NEVADA IRRIGATION DISTRICT

NID Hydro Field Office Renovation

PROJECT NO. C0011

ADDENDUM NO. 3

Item 4: Conduit Trench Restoration Detail

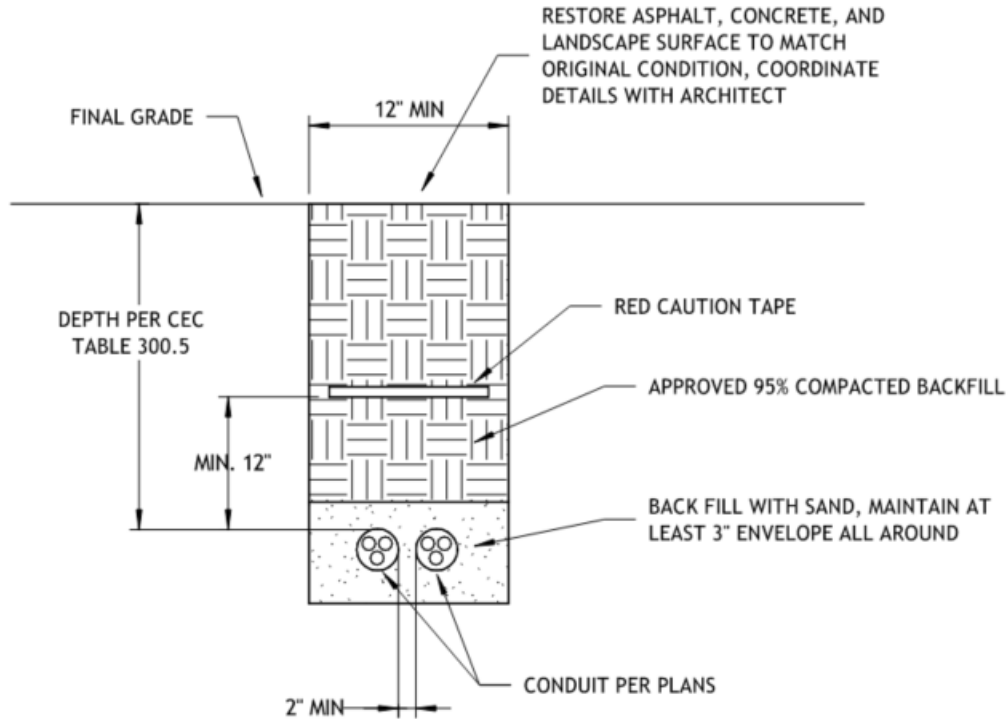
Item 4: Conduit Trench Restoration Detail

Please see the attached detail for trench restoration of electrical conduits.

1. BOTTOM OF TRENCH SHALL BE SQUARE AND CLEAN
2. REFER TO PLANS FOR QUANTITY AND SIZES OF CONDUITS
3. SAND SHALL BE FINE GRANULAR MATERIAL, FREE OF ORGANIC MATTER, MICA, LOAM, OR CLAY
4. PROVIDE MIN. 12" CLEARANCE ELECTRICAL AND OTHER UTILITIES (GAS, WATER, ETC.)
5. CONTRACTOR SHALL TRENCH FOR NEW UNDERGROUND CONDUIT(S). PRIOR TO TRENCHING COORDINATE EXISTING UTILITIES AND ALL FIELD CONDITIONS. NOTIFY ENGINEER OF RECORD OF ANY DISCREPANCIES OR CONFLICTS
